Replies to Reviewer #1

The influence of permafrost and other environmental controls on stream thermal sensitivity across Yukon, Canada

Figure 6: The weekly residual error distribution as estimated by applying a linear regression fitted to the first two weeks of July. The residuals displayed correspond to dates on or after 15 July, and the distributions are grouped by permafrost classification.

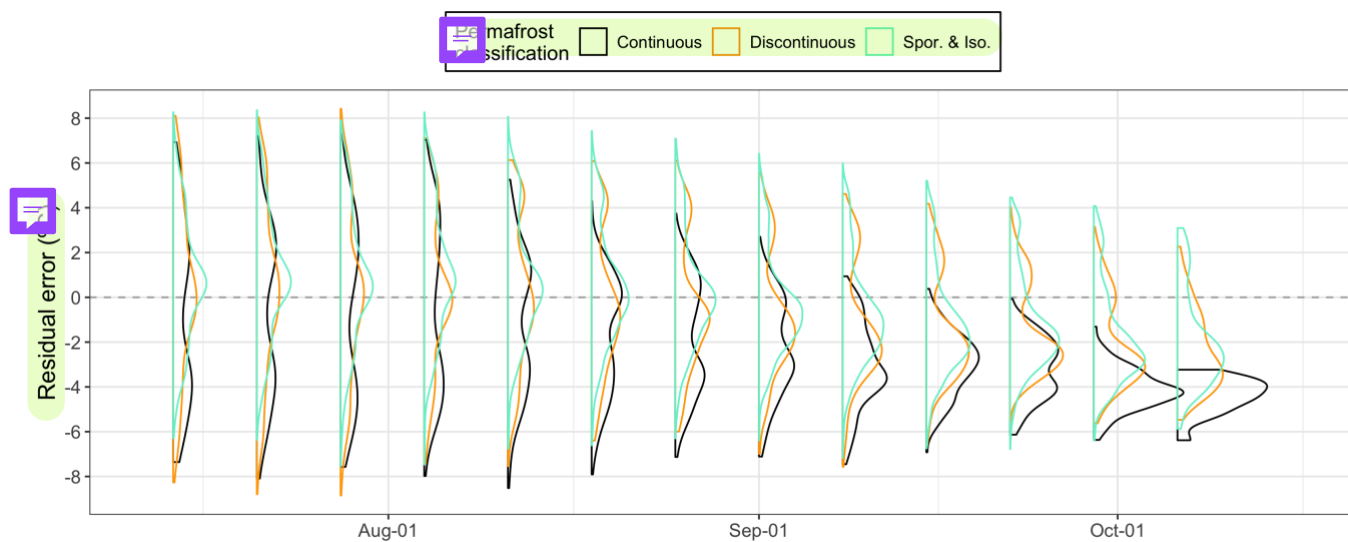
Line 426-437: Why does your model (and other models) over-predict during August – October? Any hypotheses as to why there is this seasonal variability? What is it about the permafrost catchments that makes their deviation over time greater?

We hypothesize the dynamic nature of the active layer, as it increases in thickness through a summer, is a large driver in the increasing model error during August-October due to the shifting catchment soil storage and subsurface runoff processes. We have added to the text to clarify this point.

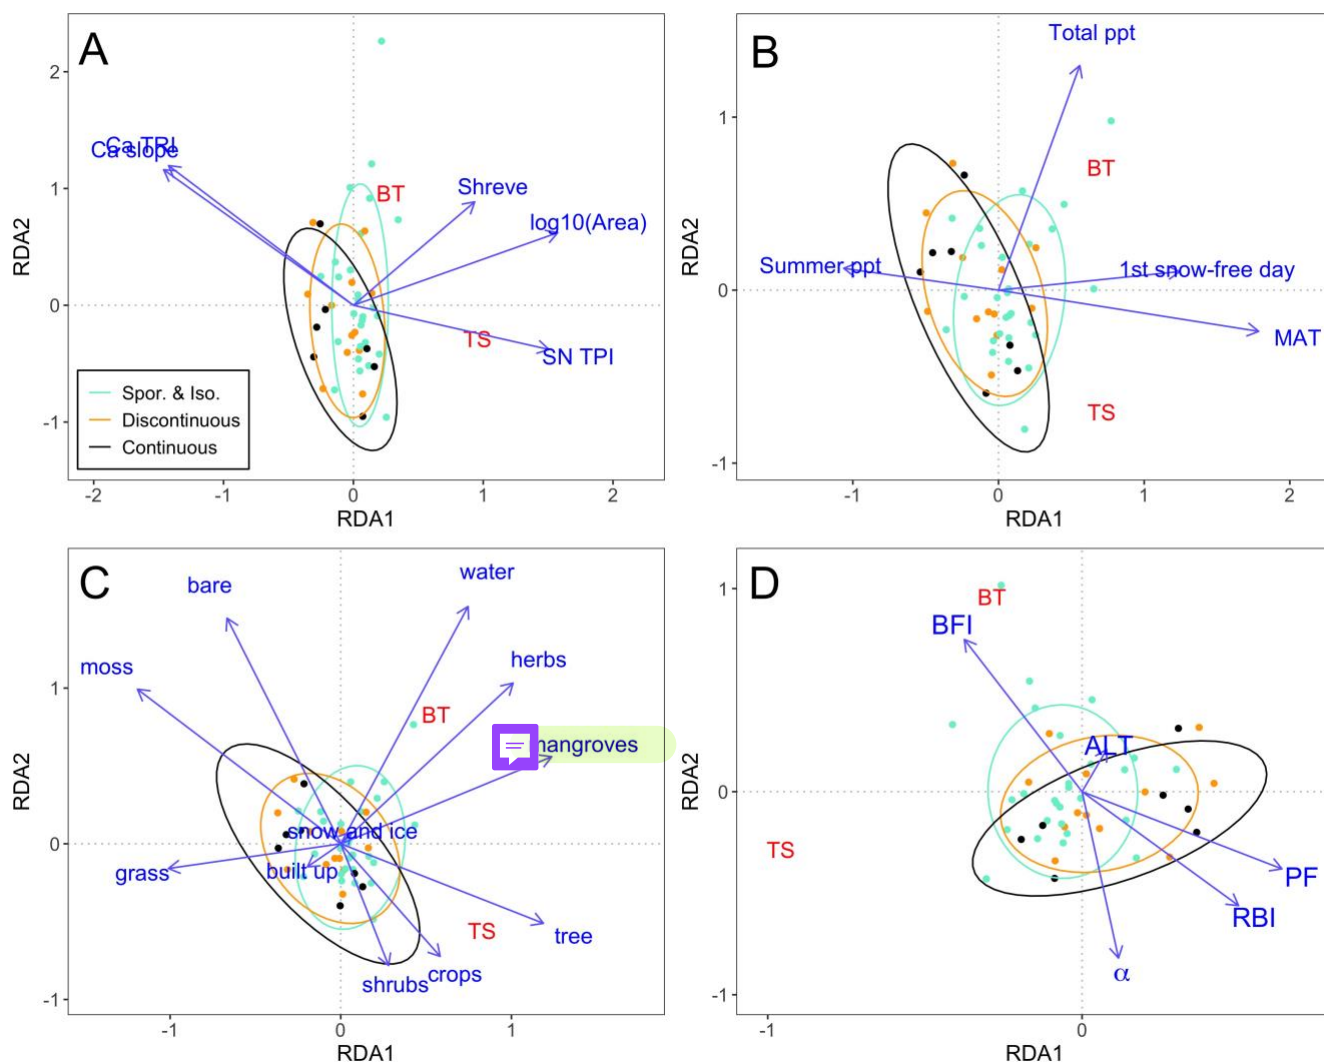
Figure 7 is a hard to interpret. Please provide a description either in the caption or in the text to help the reader interpret.

Additional text has been added to the figure caption to assist the reader in its interpretation.

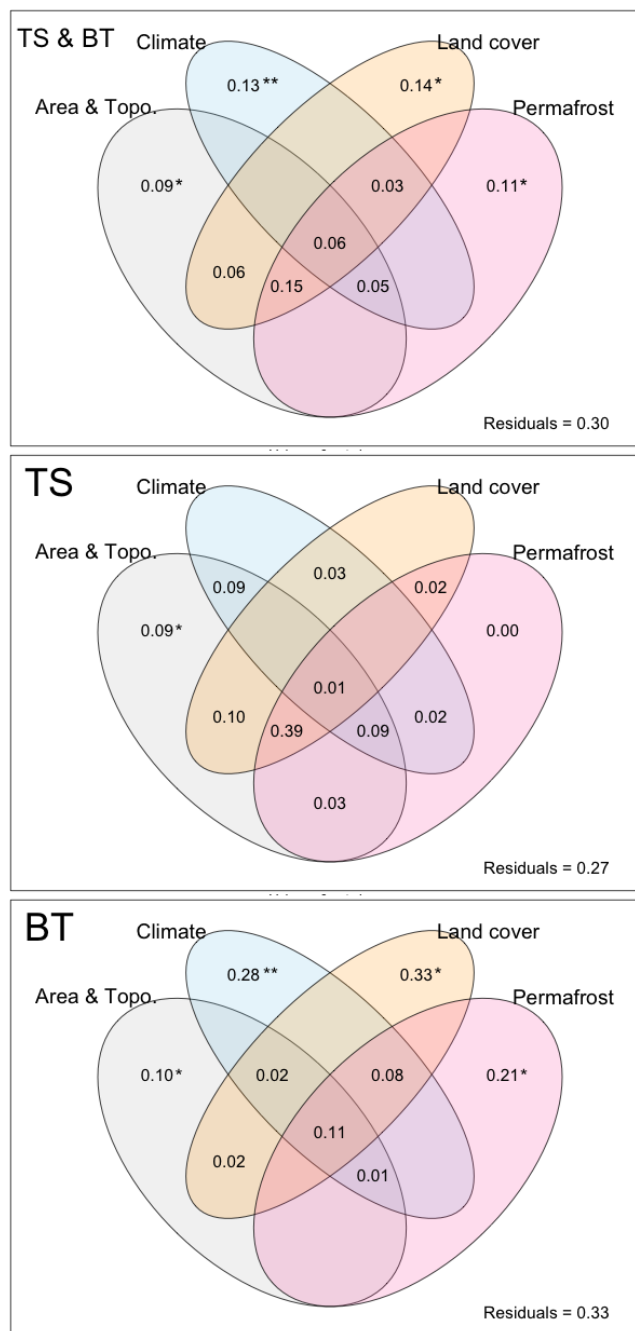
Figure 9 is also hard to interpret. Could you provide an explanation of how to interpret? Why do some of the regions in the diagram not have a value? Because they are negative?

Some additional text providing examples has been added to the figure caption. The last sentence of the caption specifies that negative values are omitted from the diagram.

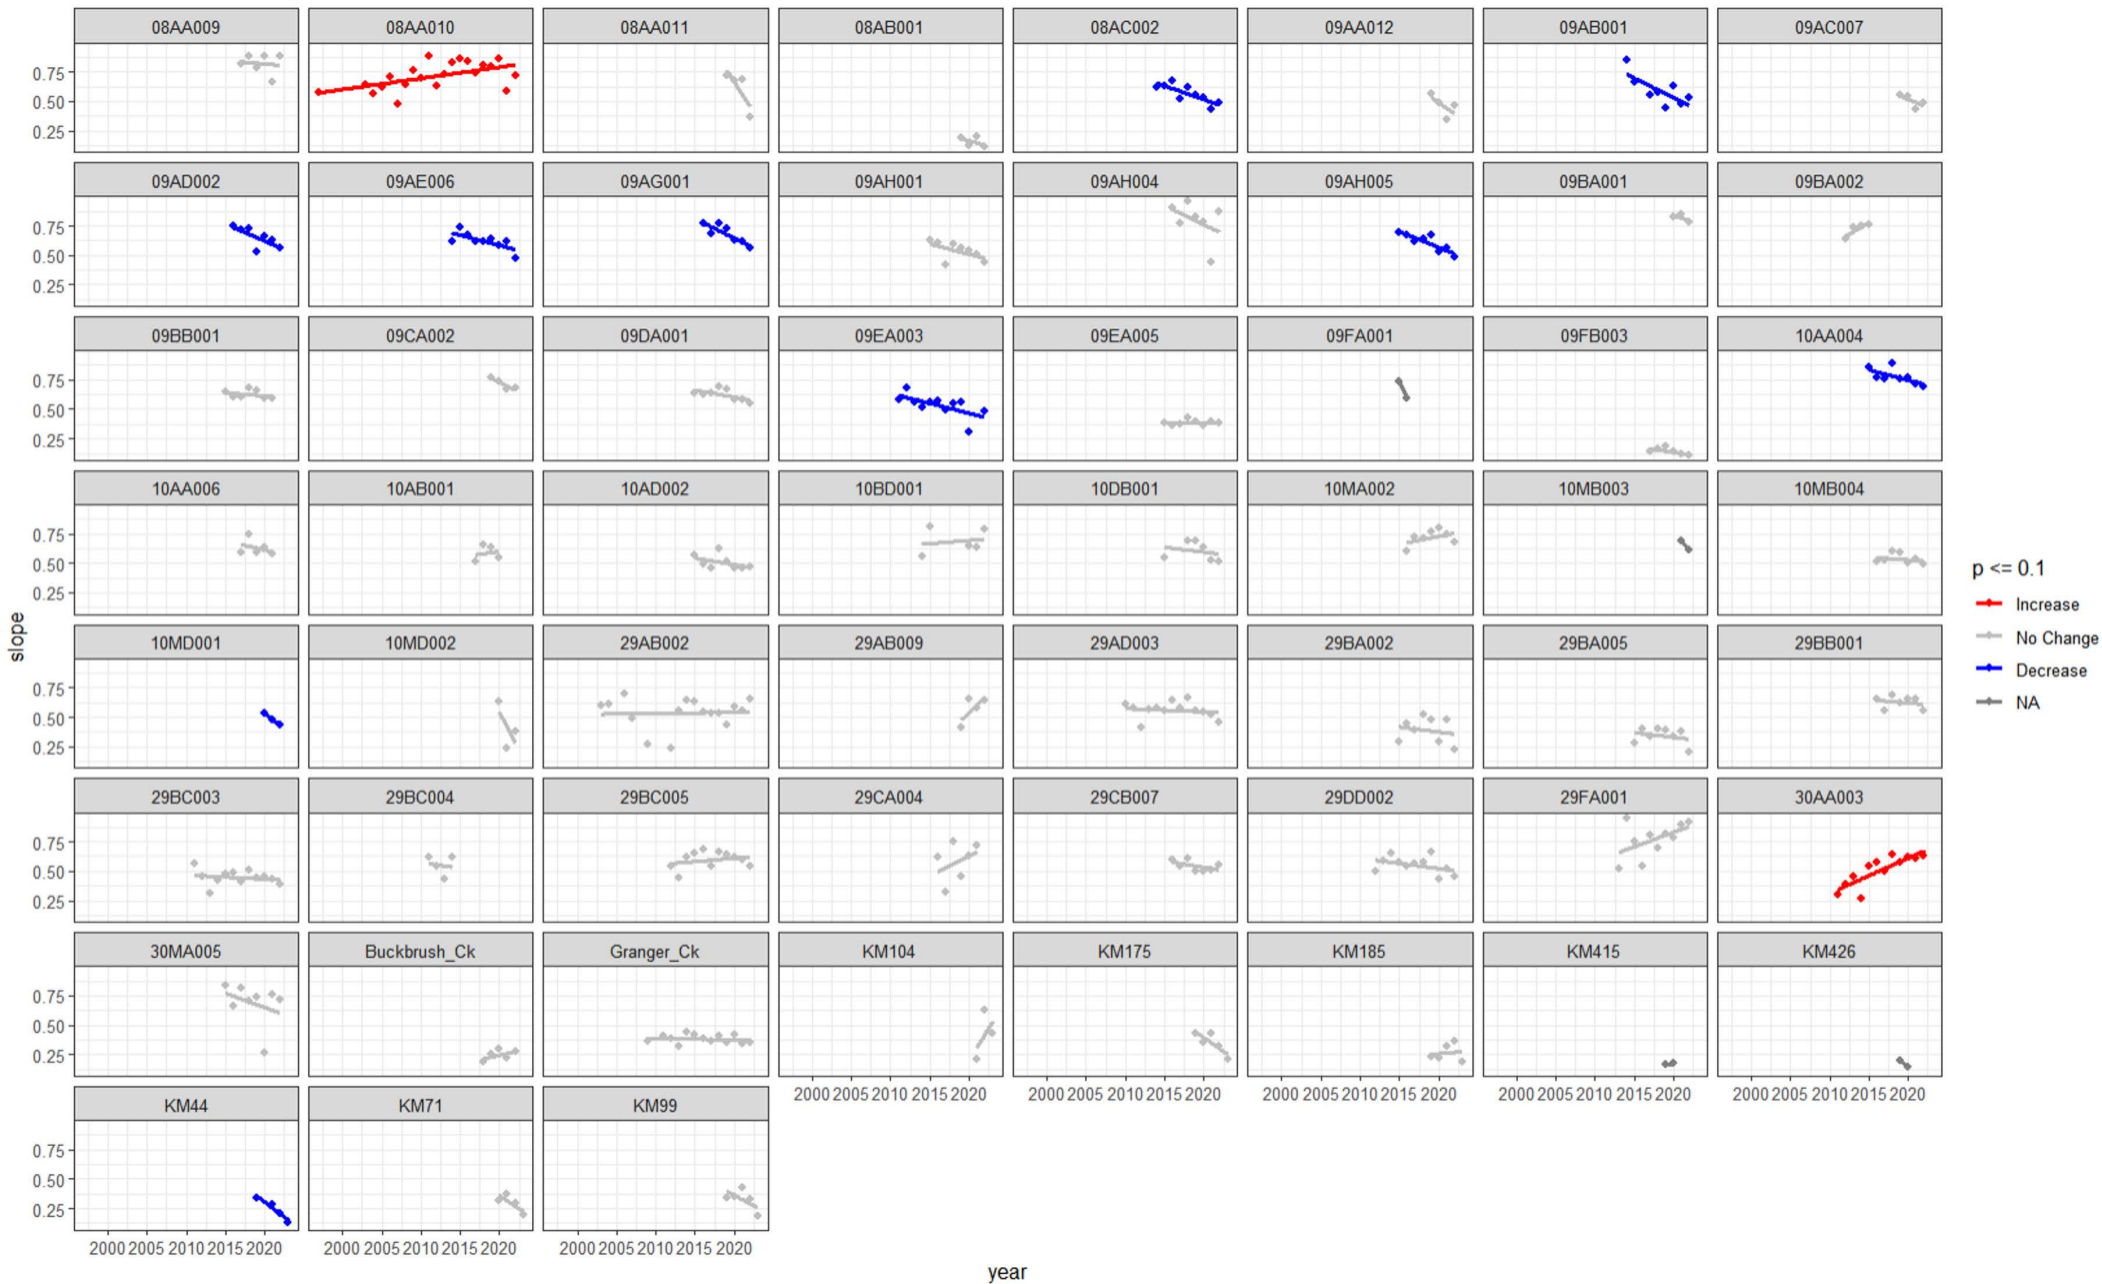
Second, we know that this system is dynamic and in flux. As such, the thermal processes that drive correlations between air and water temperature are likely also changing over time. I understand the need to use static estimates for active layer thickness and permafrost coverage (limited by data), but that does assume static conditions (over 20+ years in some cases). This should be acknowledged in the discussion and the implications explained. The more interesting/concerning pattern that emerges from the data (which the authors are commended for publishing <https://zenodo.org/records/11668943>) is that thermal sensitivity varies substantially between years with a median interannual range (max TS – min TS) of 0.22, or 41% of the magnitude of the median TS value. To make it even more interesting, the interannual variability appears to be serially correlated (e.g., demonstrating a temporal trend) with 10 stations decreasing the TS over time and 2 increasing with a p value of 0.1 (see attached figure on the last page of “egusphere-2024-1741_review_and_figure.pdf”). The authors need not add this analysis to their work to make a sound contribution, but the potential (and apparent reality) on non-stationarity should be acknowledged and discussed.

An assessment of temporal trends in thermal sensitivity and thermal regimes across Yukon was the initial research objective I pursued for this study, which forms the basis for the first chapter of my PhD thesis. After some initial analysis, I deemed there to be a lack of sufficiently long-

term data at enough study streams to represent the range of catchment sizes considered and across the range of permafrost extents. That said, the figure generated by the reviewer provides compelling evidence that there are some trends in annual thermal sensitivity that should be investigated. We have added a segment to the discussion to acknowledge the topic of non-stationarity and interannual variability in thermal sensitivity associated with changing permafrost. We thank the reviewer for this very insightful comment.
